RENESAS TECHNICAL UPDATE

Product Category	MPU & MCU		Document No.	TN-H8*-A380A/E	Rev.	1.00
Title	H8SX/1638 and 1648 Group Note on activation of the A/D converter by an external trigger		Information Category	Technical Notification		
Applicable Product	H8SX/1638, H8SX/1634, H8SX/1632, H8SX/1648, H8SX/1644, H8SX/1642	Lot No.	Reference Document	H8SX/1638 Group Hardware Manual (REJ09B0364-0100) H8SX/1648 Group Hardware Manual (REJ09B0365-0100)		
		All lots

Flowchart 1 Procedure for changing modes when starting of the A/D converter by an external trigger signal has been selected

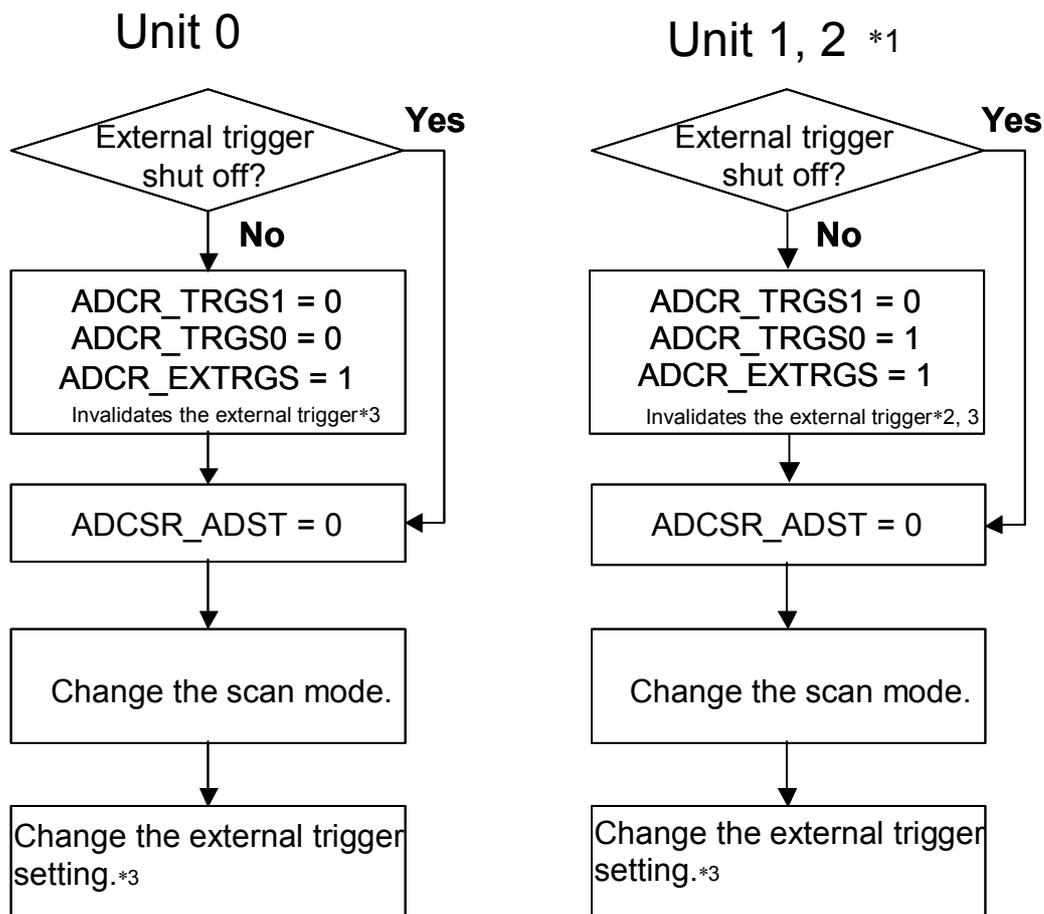
If case (2) or (3) is applicable:

Be sure to invalidate the external trigger input before changing the setting from activation by the external trigger to disabling of the external trigger or changing the scan-mode setting (changing the setting of the SCANE and ADSTCLR bits) while activation by the external trigger is in use.

Setting the TRGS1, TRGS0, and EXTRGS bits in the ADCR register to the values given overleaf invalidates the external trigger input for the start of A/D conversion.

See flowchart 1 for details of the procedure in the event of (2) or (3).

*1 Unit 2 is only applicable to the H8SX/1648 Group.

*2 Ensure that the TTGE bit in TIER of TPU unit 1 is set to 0 before making these settings, as is specified on page 504 of the hardware manual.

*3 Ensure that the TRGS1, TRGS0, and EXTRGS bits in the respective ADCR registers are set (as bytes) at the same time.
